CASE NO. UDP-S24045

| <b>REQUEST:</b>                  | Site Plan Level II Review: 59,404 Square Foot Private Recreation Facility including fourteen (14) Padel Ball Courts |
| <b>PROJECT NAME:</b>             | Sports Activity Center  |
| <b>PROPERTY ADDRESS:</b>         | 4000 and 4008 N. Federal Highway  |

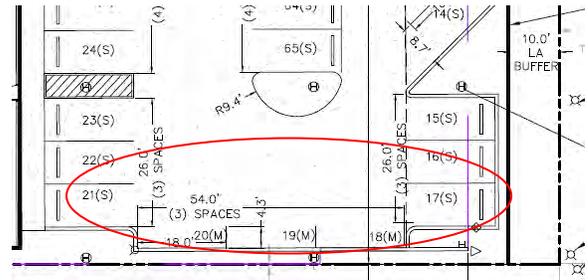
7. Pursuant to Section 47-20.11, tandem parking, not permitted in commercial development and there are areas on the site plan depicting tandem parking.
